PUBLIC PARTICIPATION SUMMARY

EnergySolutions' Class A West Embankment

License Amendment Request

Tooele County, Utah

COPY OF ENGINEERING DRAWING 10014-C08

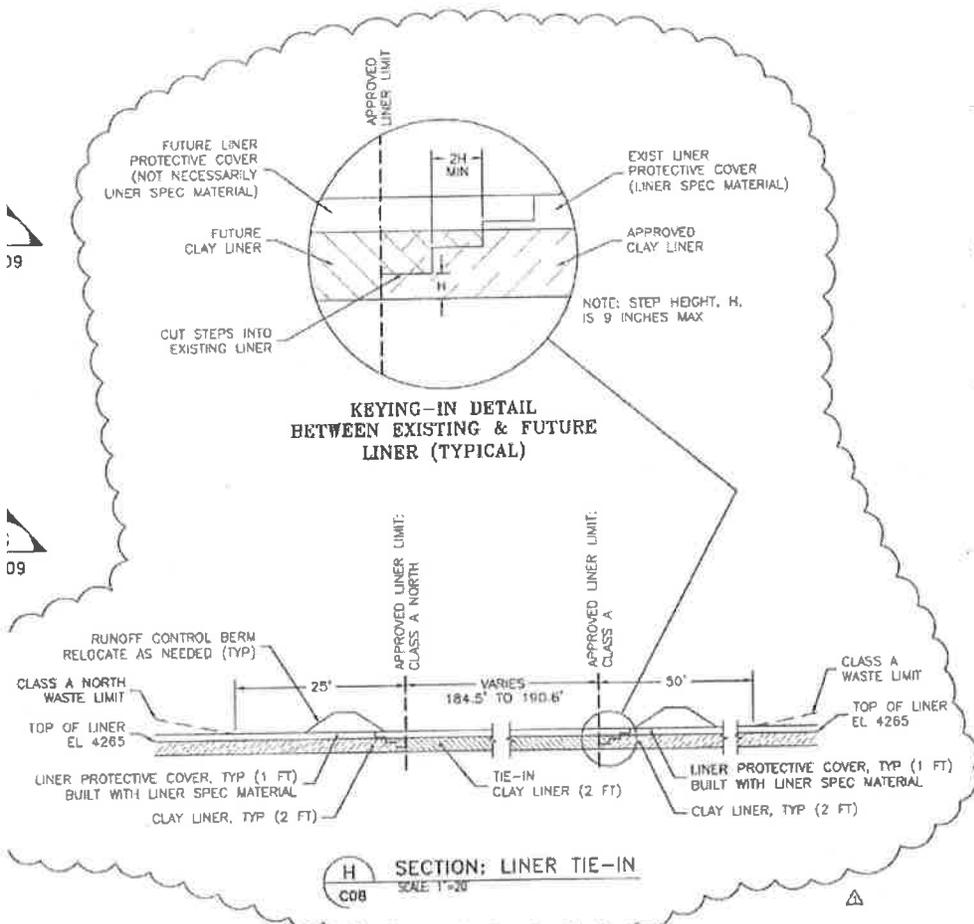
Liner Connections and Liner Differential Settlement: The Division has considered potential issues created by allowing construction of the Class A West liner system in the area between the Class A and Class A North embankments (EnergySolutions, LLC. 2012). These issues include the possibility that the different placement times and different extents of previous settlement in these three areas might compromise the integrity of the existing and proposed modified liner and cover systems.

The testing of clay properties is advisable because the Class A West cell has longer runs that may stress the clays in ways different than previously analyzed. The tests will be completed prior to approval of the Surety, as that process is described in Background, Part 1 of this Response, and the approved Surety will address any necessary changes. In the interim period, the Surety will be sufficient for the reasons specified in Background, Part 1 of this Response.
